CITY OF CODY
PLANNING, ZONING, AND ADJUSTMENT BOARD
TUESDAY, APRIL 23, 2019
CITY HALL COUNCIL CHAMBERS @ 12:00 NOON

**CITY OF CODY
PLANNING, ZONING AND ADJUSTMENT BOARD
STAFF REPORT**

MEETING DATE:	APRIL 23, 2019	TYPE OF ACTION NEEDED	
AGENDA ITEM:		P&Z BOARD APPROVAL:	X
SUBJECT:	SITE PLAN REVIEW: LOREN HAZEL SHOP BUILDING AND FOUR OUTBUILDINGS. SPR 2019-08	RECOMMENDATION TO COUNCIL:	
PREPARED BY:	TODD STOWELL, CITY PLANNER	DISCUSSION ONLY:

MEETING DATE:	APRIL 23, 2019	TYPE OF ACTION NEEDED	
AGENDA ITEM:		P&Z BOARD APPROVAL:	
SUBJECT:	FINAL PLAT OF COUGAR WEST SUBDIVISION— A 12-LOT SUBDIVISION. SUB 2018-04	RECOMMENDATION TO COUNCIL:	X
PREPARED BY:	TODD STOWELL, CITY PLANNER	DISCUSSION ONLY:

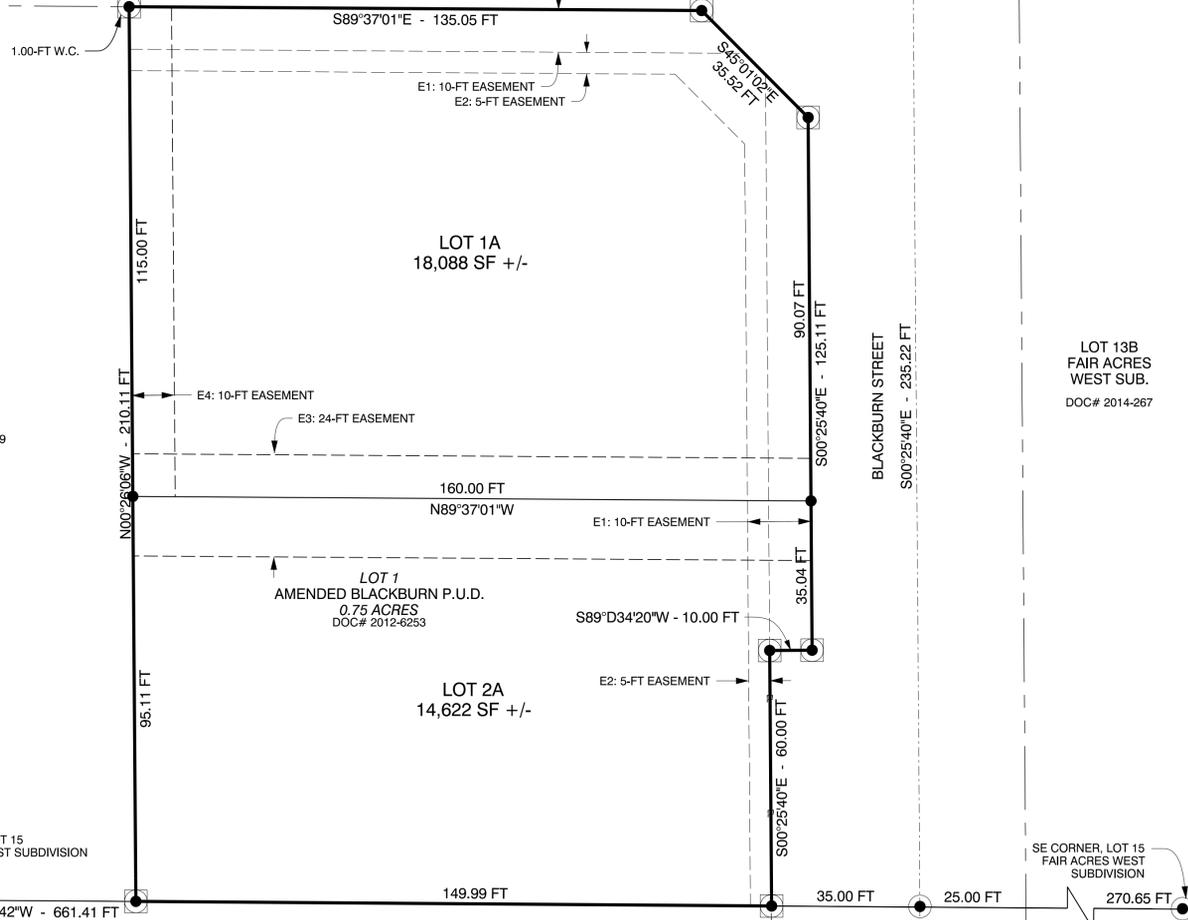
Comment: The Blackburn PUD, of which this property is a part, was not designed with alleys. A variance to the alley requirement is requested.

Comment: G Avenue and much of the section of Blackburn Street that borders this property are private streets, constructed to applicable street standards as part of the Blackburn PUD, with the exception that sidewalks were waived in this part of the development. The applicant requests that sidewalk also be waived at this time. It is noted that this subdivision will not modify the private status of the streets.

Comment: The Blackburn PUD subdivision was designed to capture and retain all runoff from this part of the subdivision in a central detention basin, based on a total of 10,000 square feet of building per lot and the balance of the property in gravel. Development of the vacant lot will include a review of the storm water situation to be sure both combined lots do not exceed the design factors.

Recommend that City Council approve the requested variances for waiver of sidewalks and alleys; and,

4 HANDICAP PARKING STALL
C1.0 SCALE: 1/4" = 1'-0"

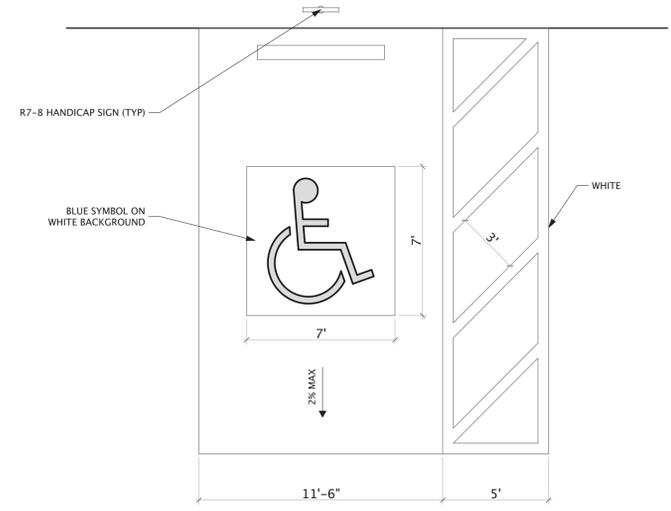
The ADA parking spaces and unloading aisles will need to meet ADA standards. Not all details are shown. The assumption is that the sidewalk is flush with the parking space and unloading aisle, and that no part of it has more than a 2% slope in any direction. Also, the truncated dome mat is not shown and the ADA sign needs a "Van Accessible" portion added, the bottom of which is at least 60" above the ground. The installation will need to meet these requirements.

1 SITE PLAN
C1.0 SCALE: 1" = 10'

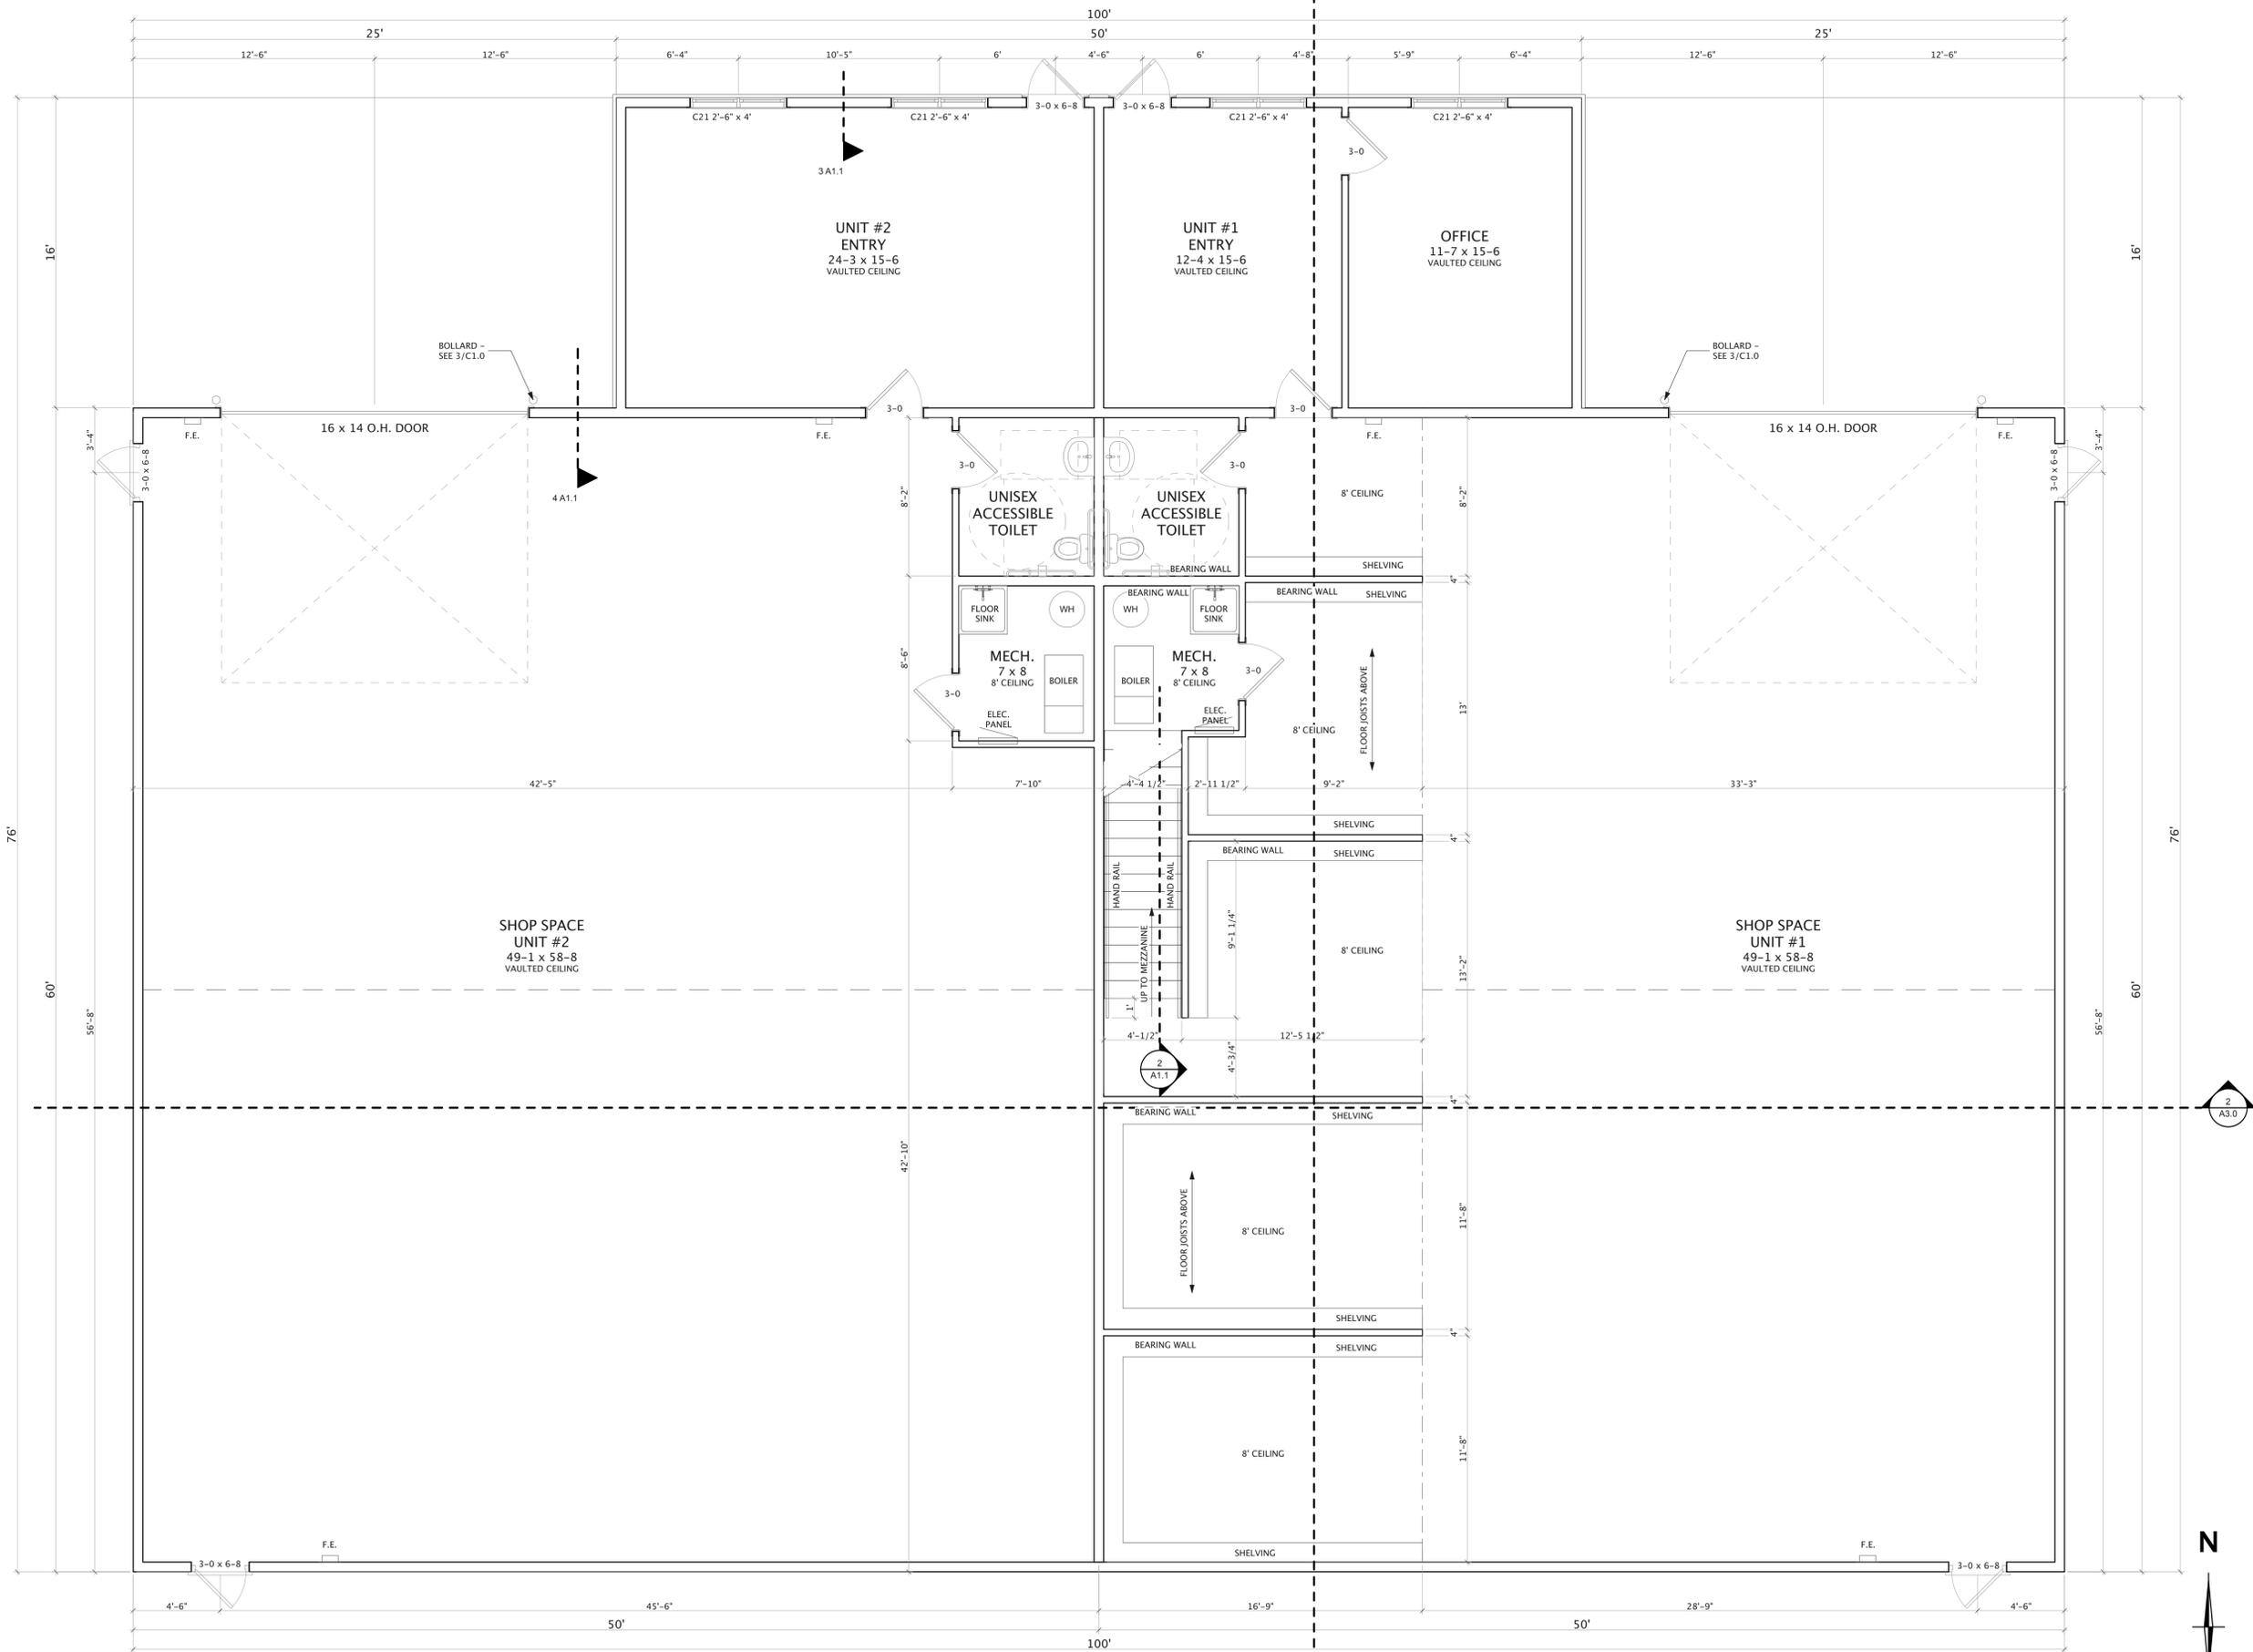
G Avenue is a dead-end local access street, and as such the parking can back directly into the street, as proposed. The number of identified parking spaces shown is only four, yet the plan is for employees to typically park at the back of the main building. There is enough room to provide a row of parking along the back of the building, with a 24-foot wide backup area, and another row of parking along the outbuildings.

It appears to be just a lack of labels, but just to clarify, all parking spaces and vehicle aisles must be improved with crushed gravel (WYDOT grading GR or W, per parking ordinance).

The site plan shows the water service coming from the northeast corner of the property—the service is at the northwest corner. Show the corrected route on the plans submitted for the building permit.

The proposed dumpster location is shown on the site plan.

3. All areas used for parking or active vehicle use must have a gravel surface, or better.
4. Correct the site plan to show the water service coming from the NW corner of the property.

5. Provide an updated grading/drainage plan, as discussed in the staff report. (Either the drainage swale along the south end of the property shall have a capacity of at least 350 cubic feet, and be designed to overflow towards G Avenue (likely need ditch along east property line), or the site graded to flow to G Avenue with the roof runoff from the outbuildings retained.)

DATE: APRIL 5, 2019
 PROJECT: 180480
 SHEET: **C0.07**

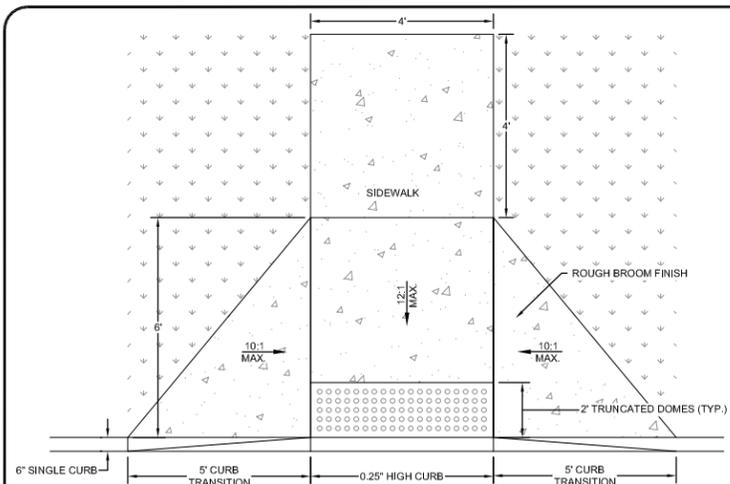
5. The storm water basin shall be lined with decorative rock/cobble or grass. *(Status: The plans show "field rock" (see Sheet C0.07) on much but not all of the swale. The applicant should clarify if rock will continue to the edge of the swales, or if a native grass will be provided.)*
